Rezoning Transportation Analysis

Petition Number: 2021-168

Date	Description
11-19-2021	First Review (KP)
12-20-2021	Second Review (KP)
03-21-2022	Third Review (KP)

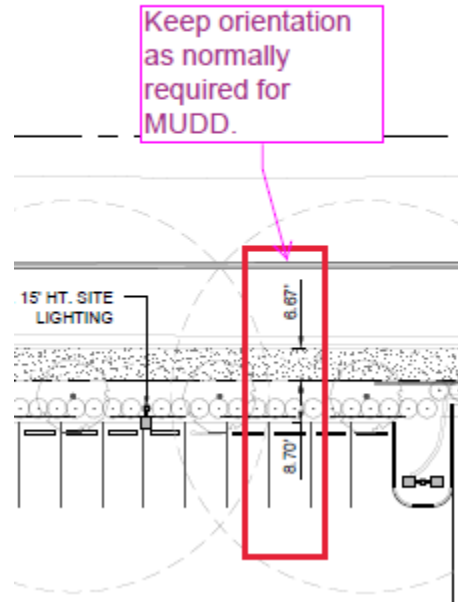
4. ~~Revise site plan and conditional note(s) to commit to construct an 8-foot planting strip, and 6-foot sidewalk along the site's frontage of Berryhill Road and State Street. The planting strip and sidewalk~~

shall be oriented where the planting strip is located in between the sidewalk and back of curb. The site plan shall label and dimension both items from the back of curb and gutter.

~~Comment Resolved as a result of 12-08-2021 Coordination Call with Petitioner~~ Streetscape was previously approved due to site constraints.

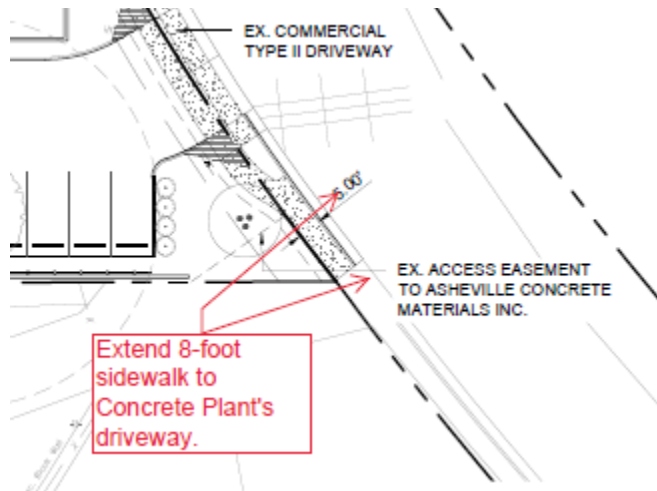
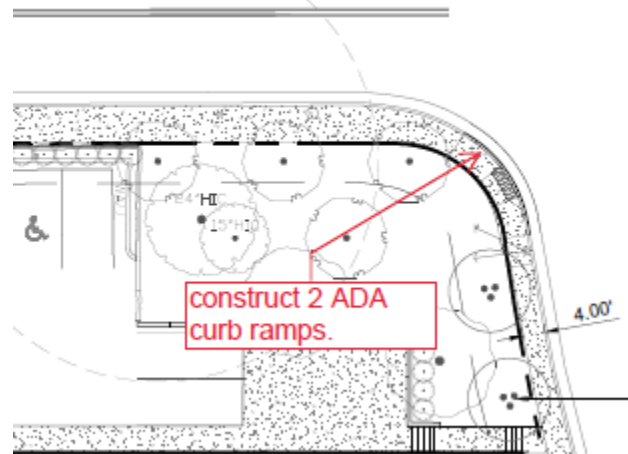
5. ~~Revise site plan and conditional note(s) to commit to construct a minimum 8-foot sidewalk along the site's frontage of State Street and Berryhill Road where the sidewalk is located at the back of curb. Additionally, the sidewalk width will be maximized where the existing building(s) or other site constraints inhibit an 8-foot sidewalk. These location(s) and sidewalk width(s) will be subject to approval by CDOT during permitting. Lastly, remove conditional note 2.b~~

~~Comment Resolved as a result of 12-08-2021 Coordination Call with Petitioner:~~ Sidewalk will be maximized as much as possible..
